Technical Note

Vertex™ Software Release 1.23.1

1998-0736 Rev 1 2/08

Software update provides improved performance

Figure 2 -- Point Detail Screen

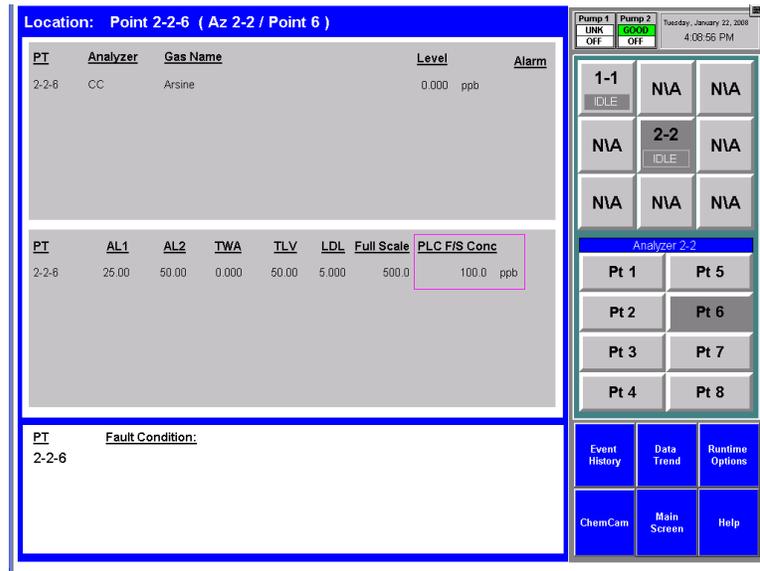
Along with the change to the Point Configuration screen, the PLC F/S Conc information has been added to the point detail screen. The new data is shown in the pink rectangle in Figure 2.

Figure 3 -- Alarm Test Screen

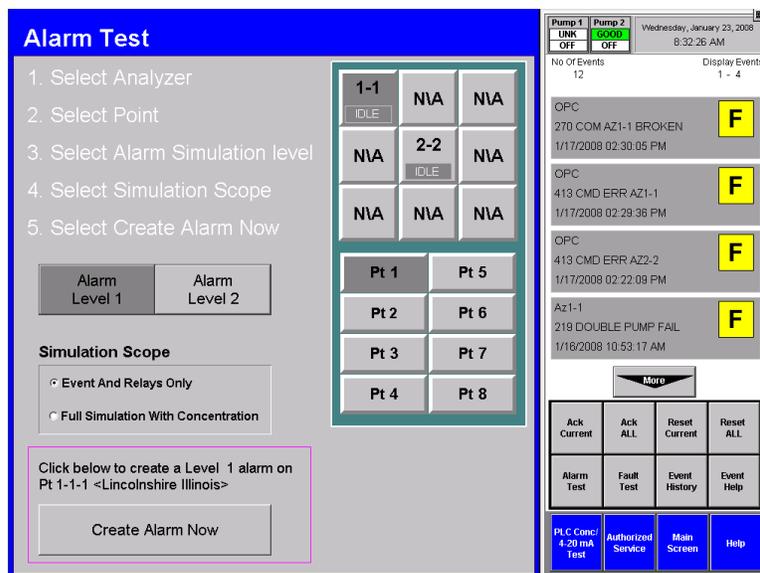
The HMI screen for alarm and fault simulation has been made more intuitive. The changes to the alarm simulation screen are shown below in the pink rectangle in Figure 3, changes to fault simulation in Figure 4. Specifically, the analyzer and point selection are retained after an alarm or fault test to ease repeating the test. Also, a label has been added above the button that indicates what is being simulated. For alarms, the mnemonic location name is displayed. This is "Lincolnshire, Illinois" in the example below. The button text is improved to make it clear that pressing the "Create" button is the final step before an alarm or fault.

Figure 5 -- Configuration Editor

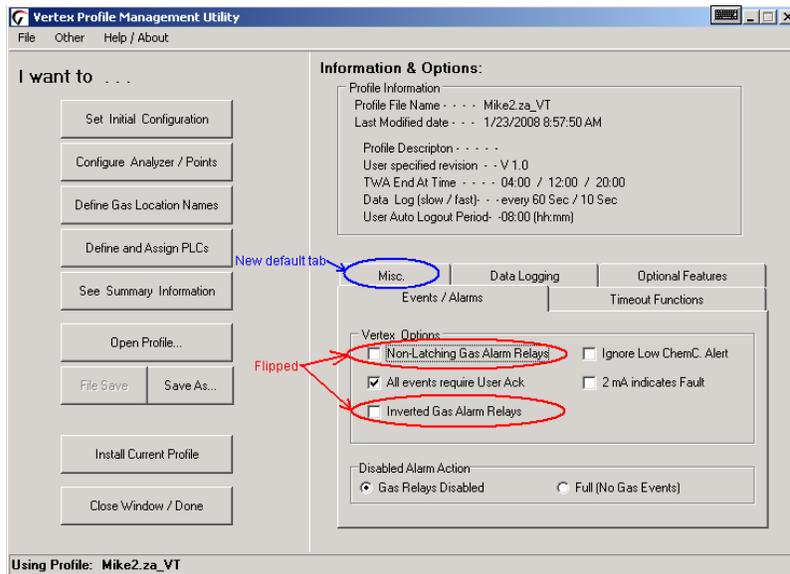
The profile editor has been changed to reduce the danger that the “Inverted Gas Alarm Relays” setting can be changed inadvertently. To accomplish this, the five tabs shown in Figure 5 are changed such that the “Misc.” tab is now visible by default and not the “Events / Alarms” tab. Furthermore, the checkboxes are rearranged such that “non-latching” is in the top left position instead of “invert relays”. These changes are highlighted in color in Figure 5.

As before, actually changing the “invert relays” checkbox causes a message box to appear: “Do you really want to change the setting for inverted relays?”.
